BID ADDENDUM No. 5

Re: Bedford UFSD
Phase 2 – Bond Improvements at
Fox Lane High School, Fox Lane Middle
School, Administration Building
BBS File No. 23-131a-c

1. 23-131b Drawing A8.01 – Door Schedule and Elevations

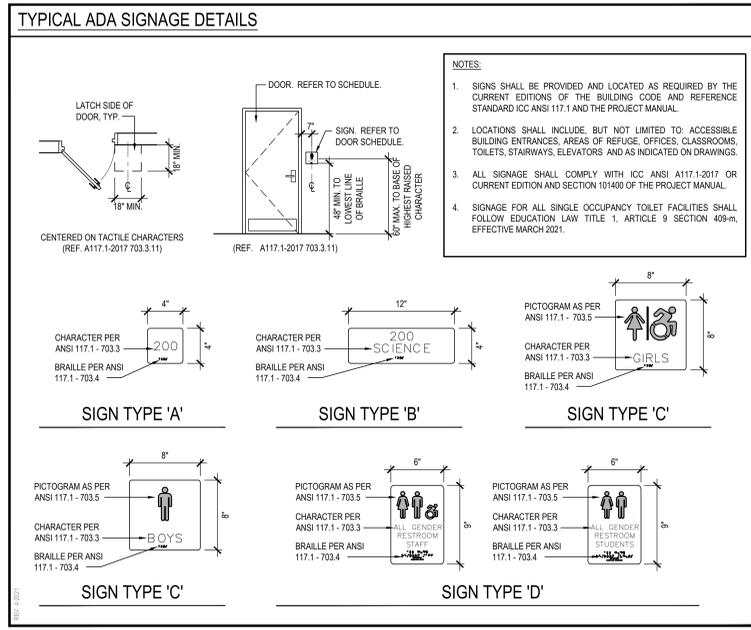
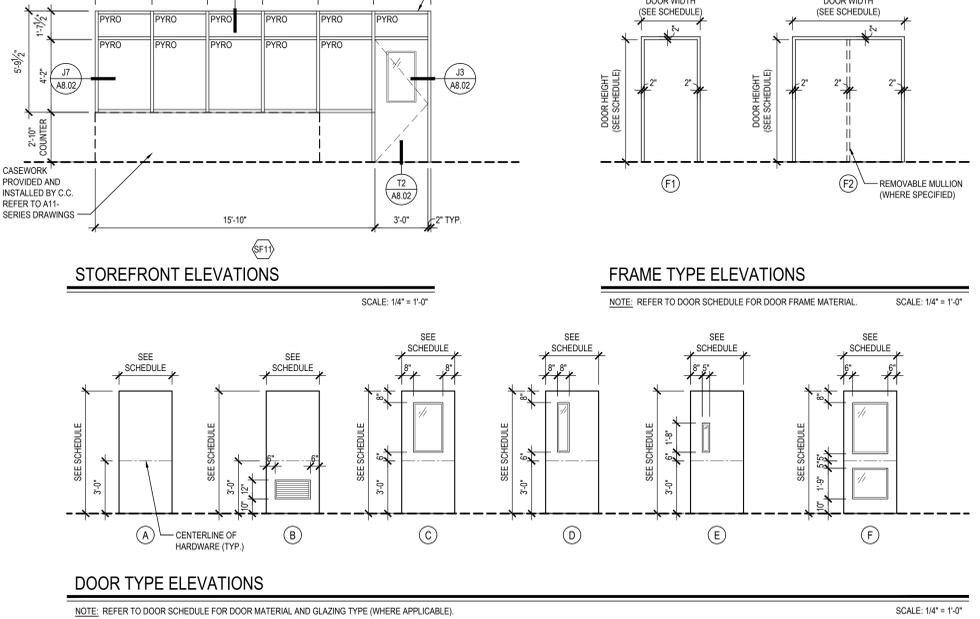
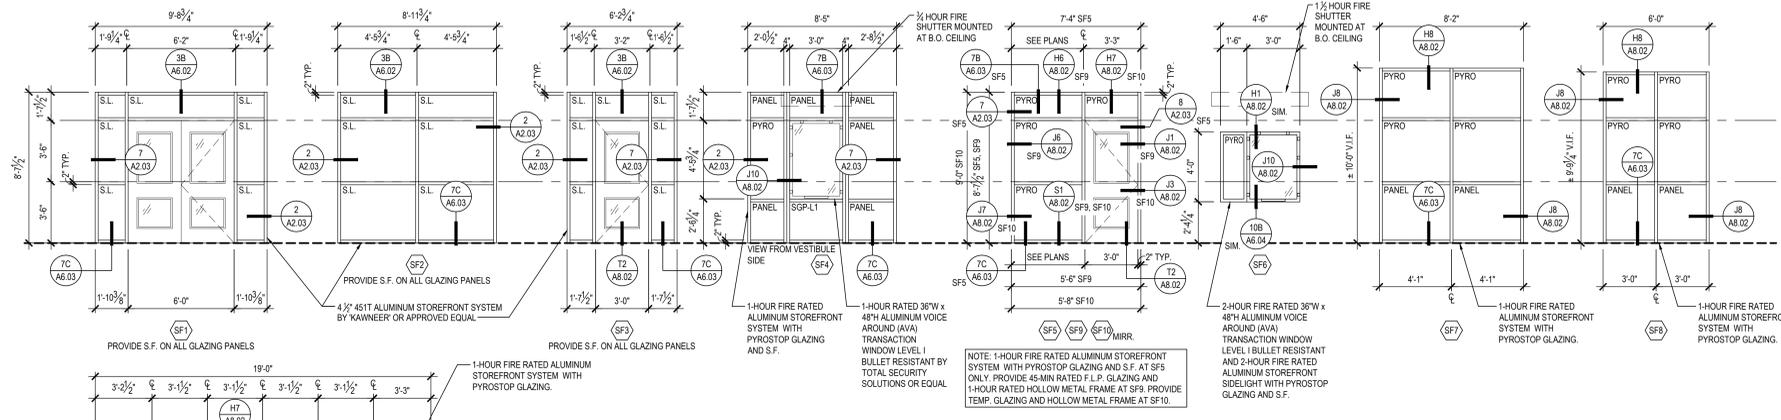
- a. Construction drawing shall be deleted and replaced with the attached. This drawing was inadvertently excluded from Addendum #4.
- b. All TGP fire-rated assemblies shall use 'Pyrostop' glazing as per manufacturer's recommendations. All other references to 'Pyrostop' glazing in fire rated assemblies shall be Fire-Lite Plus glazing.
